**VIRGINIA ELECTRIC AND POWER COMPANY
RICHMOND, VIRGINIA 23261**

VIRGINIA ELECTRIC AND POWER COMPANY
NORTH ANNA POWER STATION UNIT 2
RESPONSE TO REQUEST FOR ADDITIONAL INFORMATION
THIRD INTERVAL INSERVICE INSPECTION PROGRAM

**Request for Additional Information
North Anna Power Station Unit 2
Third Interval Inservice Inspection Program**

DETAIL A

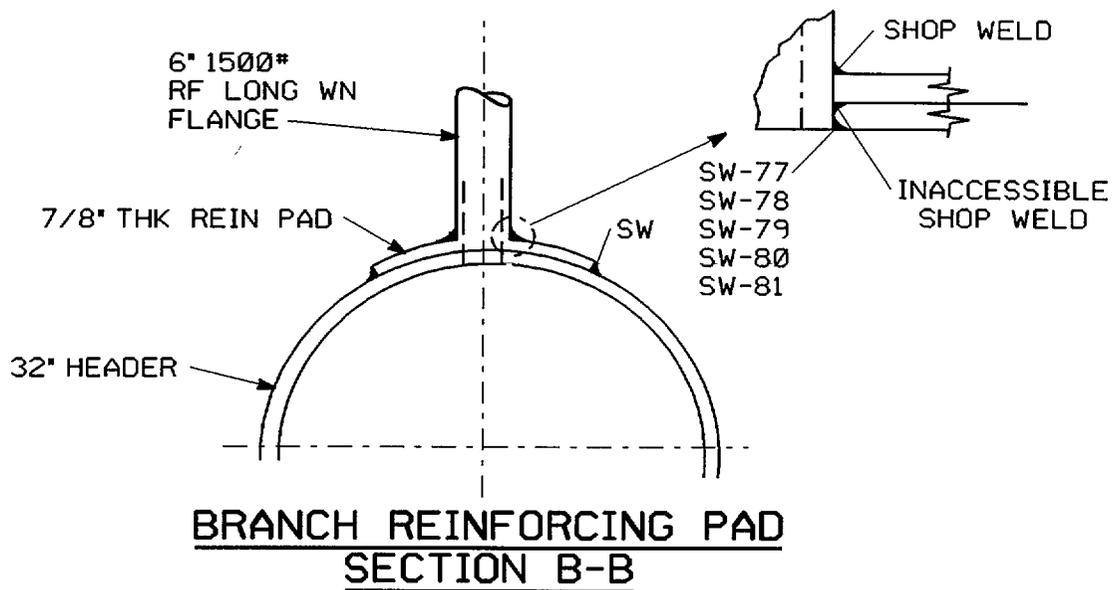
Request for Relief NDE-001 – The licensee submitted an alternative to perform surface examinations of the pipe-to-pipe fillet welds of the reinforcement pads associated with each branch connection weld. In order for the proposed alternative to be acceptable, please provide the following:

1. Please provide sketches or photos with sufficient details so that the staff could determine the impracticality in performing the Code-required surface examinations of the subject welds.

Response: The following two "Detail Sections" were taken from drawing 12050-WMKS-101A-1, which is referenced in the request for relief. They are typical of the three sets of branch connections included in NDE-001.
